**DEPARTMENT OF TRANSPORTATION
STATE OF GEORGIA**

SUBJECT APPROVED PROJECT CONCEPT REPORT

FILE: P. I. No. 0007103, Walton County **OFFICE** Preconstruction
 CSSTP-0007-00(103)
 SR 138 Extension **DATE** April 18, 2006

PROJECT CONCEPT REPORT

**PROPOSED RURAL HIGHWAY
CONCEPTUAL INTERCHANGE AT
US 78/SR 10
SCALE: 1"=400'**

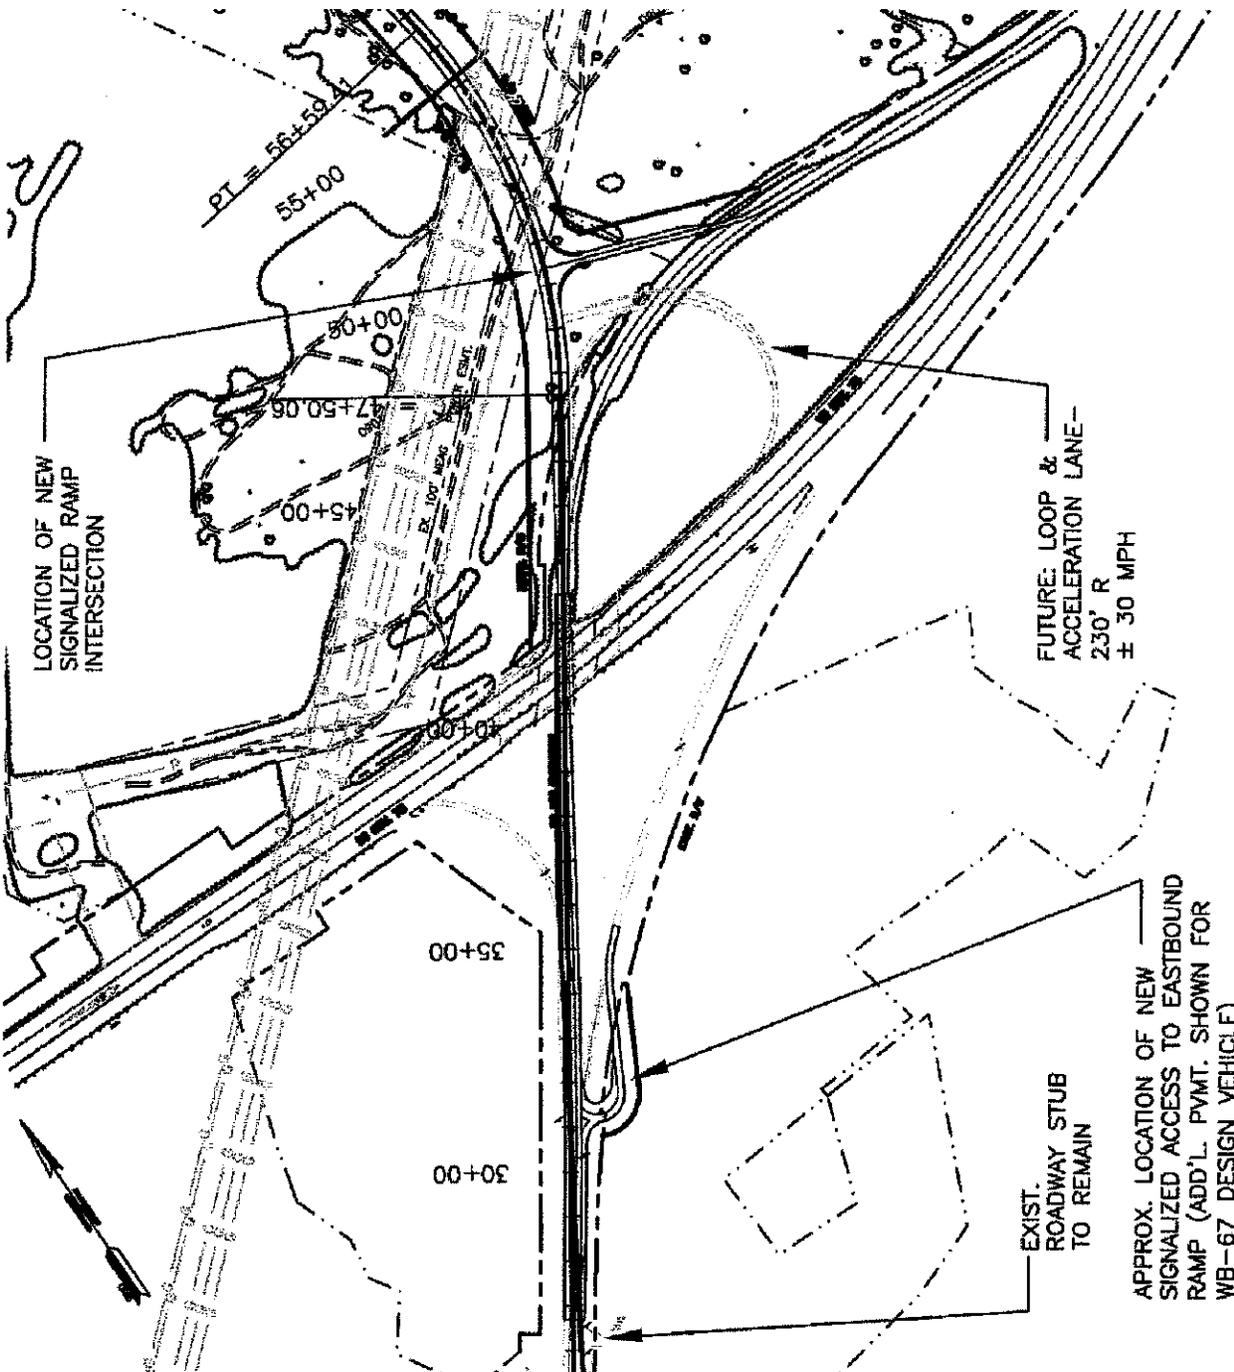
8. If the property owner desires a portion of the U.S. 78/S.R. 10 off-ramp R/W, GDOT would need to "surplus" this area (shown on the concept layout) by going through the

- Federal D.O.T. It is likely that this would not be allowed for this project. The state prefers to follow the existing off-ramp alignment up to the proposed intersection with the new extension.

9. The roadway section under the U.S. 78/S.R. 10 bridge was discussed in length. The 9-foot dimension between the travel lane and the bridge column would constitute a "design exception". The project may require the use of a Type 7C wall and pipe the adjacent ditch to avoid trapping water. Also, the standard for guardrails located 2 feet from the edge of pavement includes curb and gutter and a sidewalk; the guard rail sections may be shown at this location, but no curb and gutter and sidewalk is proposed. The roadway under the bridge should be addressed as an exception in the concept report.

PROPOSED RURAL HIGHWAY T.S. 1 RURAL 3-LANE SECTION (D.S. 45MPH) NORMAL CROWN

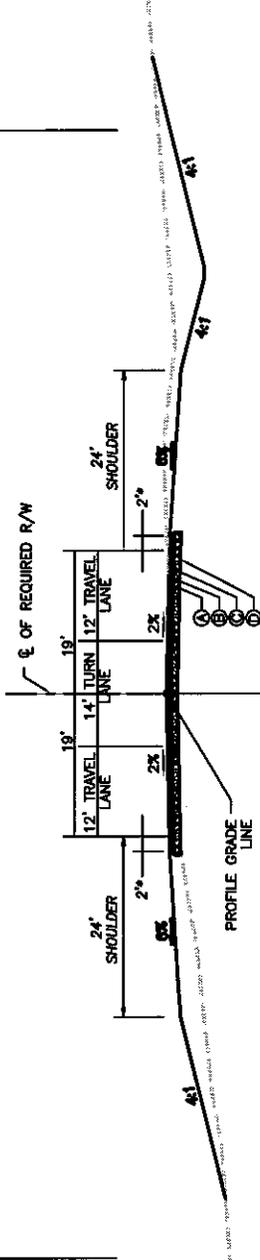
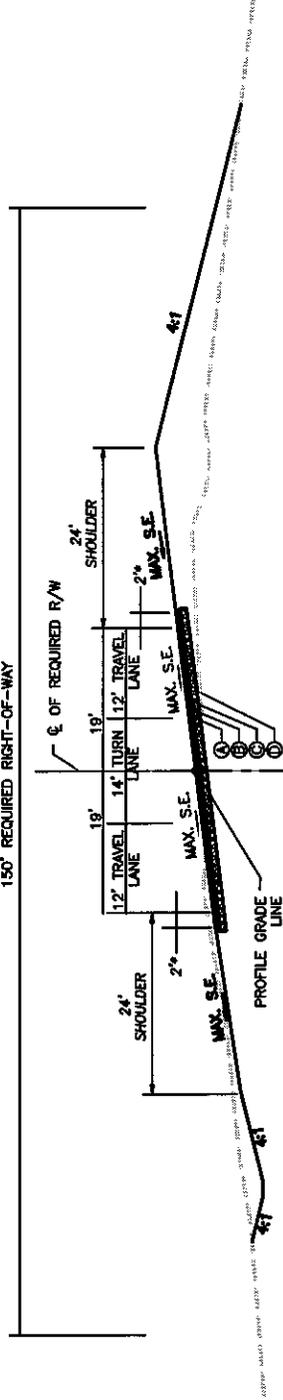
25. The typical section for the super elevated mainline should still show the shoulders matching the maximum SE (8% implied), even though this SE condition will not occur for this project. It is acceptable to GDOT that all SE design values for the mainline remain under 7%.

26. The typical section sheet for the mainline must include a shoulder slope transition control box (similar to the standard slope control box). The GDOT Microstation cell should be added to show this information; this will establish correct shoulder slopes for each stage of SE transition.
